From: Stacey Lui <stacey.lui@straitsupport.com>
Subject: Re:
Date: 10 March 2020 at 2:34:14 pm AEST
To: Nathan PHILLIPS <Nathan.Phillips@smec.com>
Cc: Chris TAIFALOS <Chris.Taifalos@smec.com>

ERUB FISHERIES MANAGEMENT TORRES STRAIT ISLAND CORPORATION

DRAWN BY: [Name]		CHECKED BY: [Name]		DATE: 15/11/15	
PROJECT NO: 3003657		PROJECT NAME: FREEZER ROOM UPGRADE DARNLEY ISLAND		PROPOSED REMEDIATION PLAN AND SECTION

PROPOSED LAYOUT & FRAMING PLAN
SCALE: 1:50

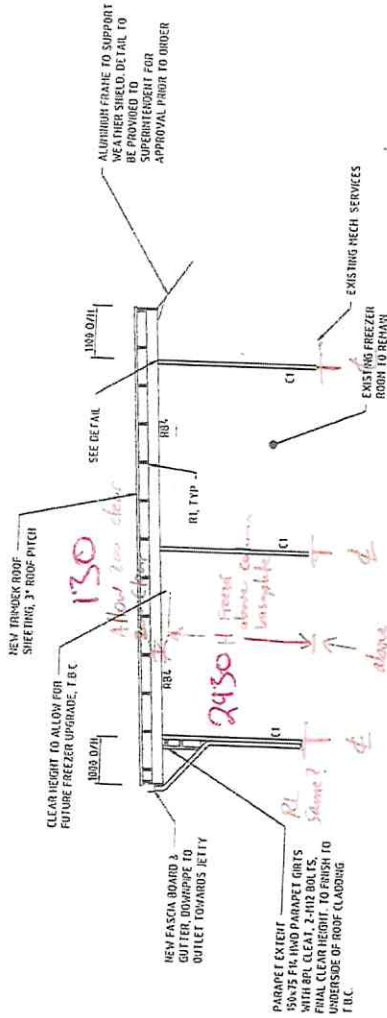
As just discussed with you over the phone, my understanding is that the fall of the new proposed roof as per plans falls to the jetty, and if this is the case we should require

- 3 x high columns all same length
- 3 x mid columns for RB4 less 50mm all same length - the centre / middle post I will need to discuss as it is in between internal panels.
- 3 x low columns all same length

I will need to confirm materials and direction of fall prior to placing order, as you have advised your understanding is the fall is to an area that has double gates and a ramp as per SK01 B

3. Dimensions that need to be accurately taken to allow us to assist in determining column heights for you. It is understood that existing column heights are all the same across the three existing frames? We need:
- a. D1 - 1700
 - b. D2 - 3900
 - c. D3 - 7800
 - d. D4 - 4000
 - e. D5 - 4190
 - f. Height of freezer - **2860** distance taken from top of freezer to top of existing column steel baseplate level **130** – we will then allow for grout.

From your provided information, column heights are as follows, please note that we take no responsibility for the existing information provided and the below should be confirmed:

Where under RB3:

- 2 No. 3.13m high
- 2 No. 3.33m high
- 2 No. 3.54m high

Where under RB4 (less 50mm):

1 No. 3.08m high

1 No. 3.28m high

1 No. 3.49m high
